ADDENDUM NO. 03

Three Rivers Community Schools District Signage 700 Sixth Avenue Kalamazoo, MI 49093

OWNER THREE RIVERS COMMUNITY SCHOOLS **PROJECT** DISTRICT SIGNAGE PACKAGE A/E Project 5-6405 **ADDENDUM 003 PURPOSE** THIS ADDENDUM SHALL FORM PART OF THE BIDDING DOCUMENTS. CHANGES, ADDITIONS, CLARIFICATIONS OR DELETIONS HEREIN SUPERSEDE THE DRAWINGS AND SPECIFICATIONS. BIDDERS SHALL INCLUDE ON THE PROPOSAL FORM ACKNOWLEDGEMENT OF THE RECEIPT OF THIS ADDENDUM. **ATTACHMENTS New Specifications: None** Reissued Specifications: 10 14 26 New Sheets: C2.06 Reissued Sheets: G0.00, G2.01, C2.01, C2.02, C2.03, C2.04, C2.05 ARCHITECT-ENGINEER **GMB** www.gmb.com 616.796.0200 **CONSTRUCTION MANAGER** THE SKILLMAN CORPORATION www.skillman.com 269.350.5757

DEMOLITION AND SITE PLANS AT MIDDLE SCHOOL

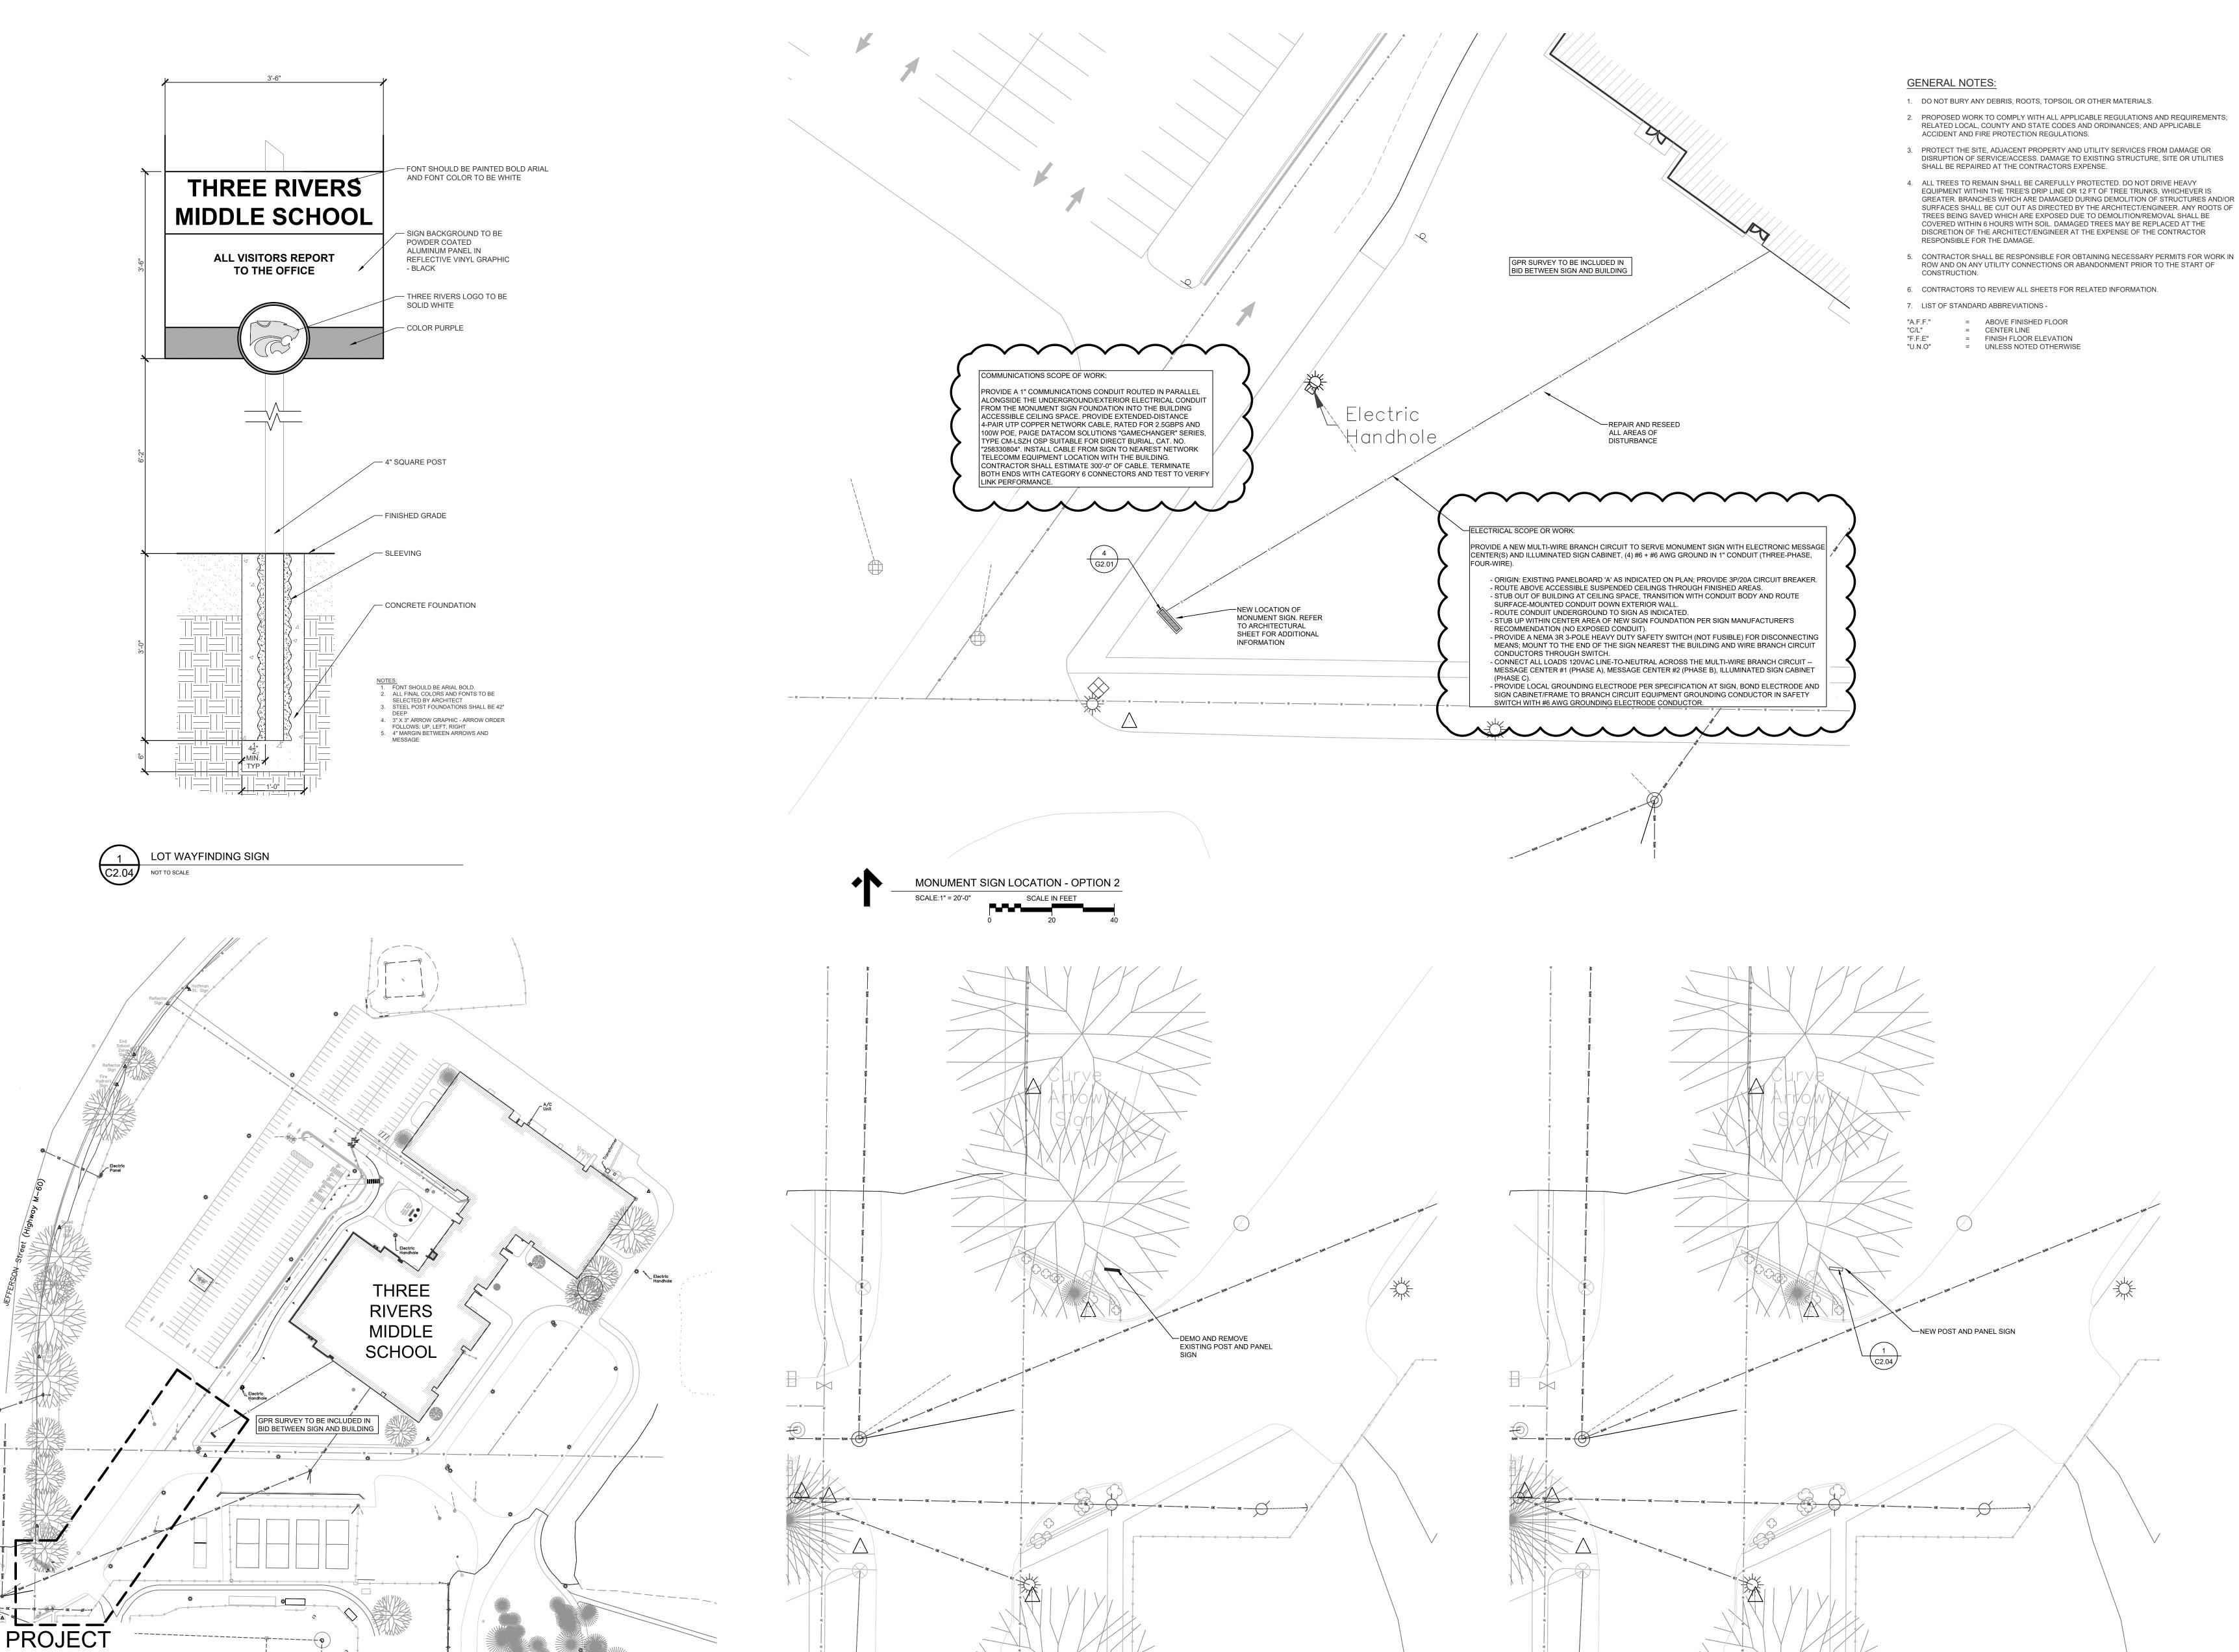
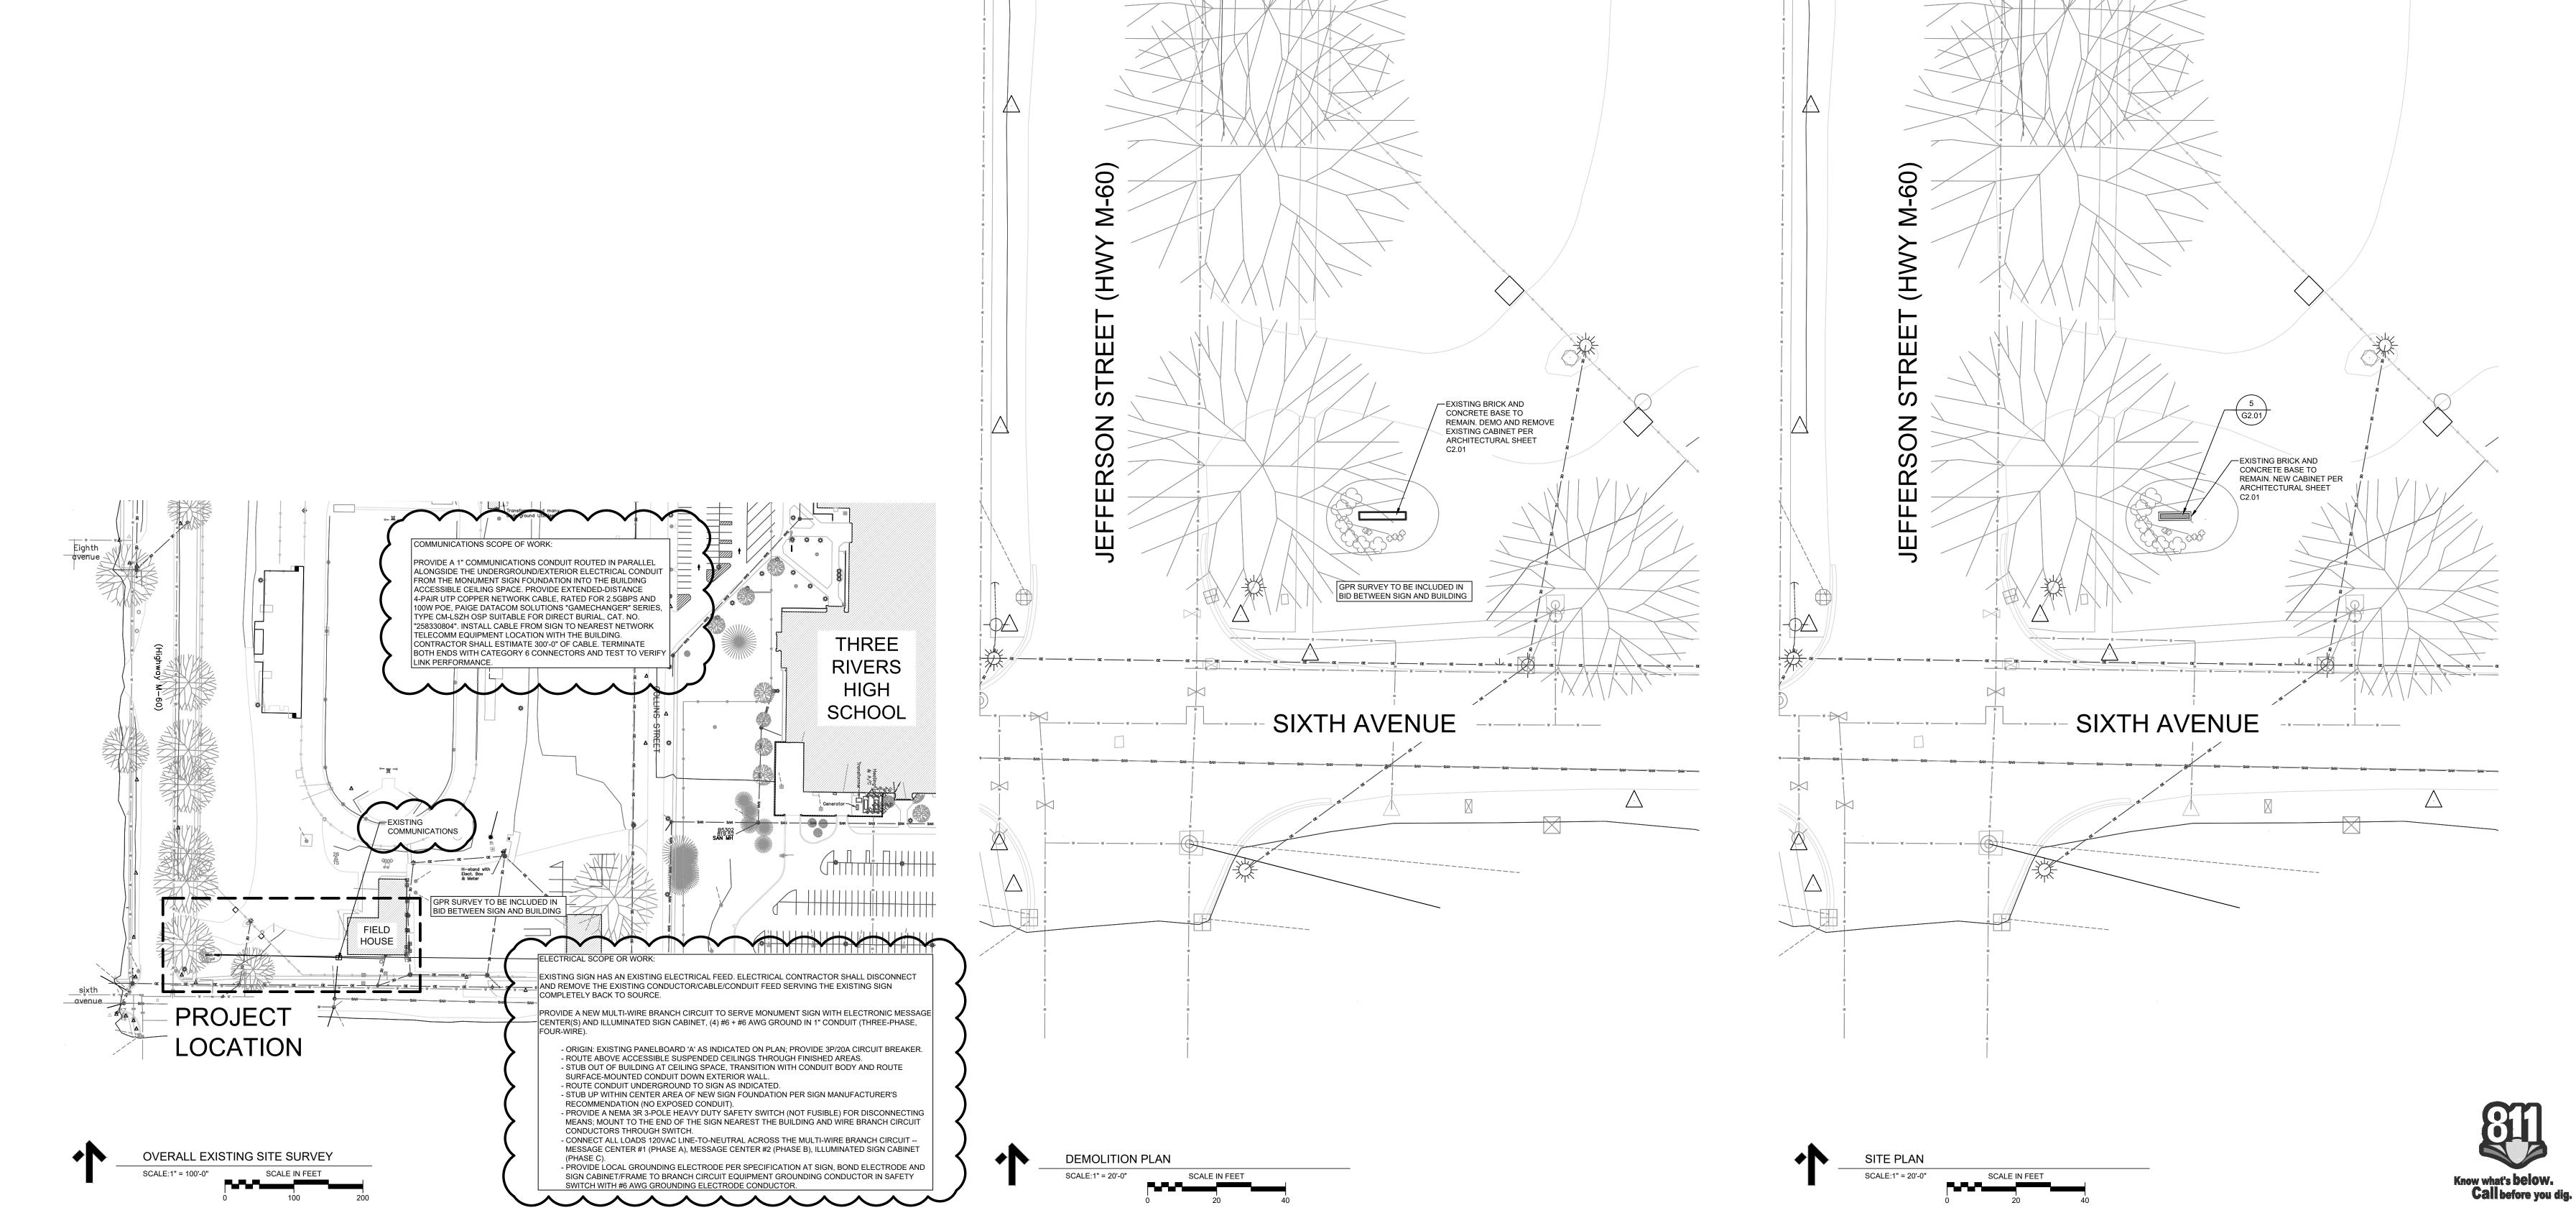
ITEM NO. 7 SHEET C2.04 – DEMOLITION AND SITE PLANS AT MIDDLE SCHOOL (REISSUED)

Revised electrical and communications requirements to serve monument sign.
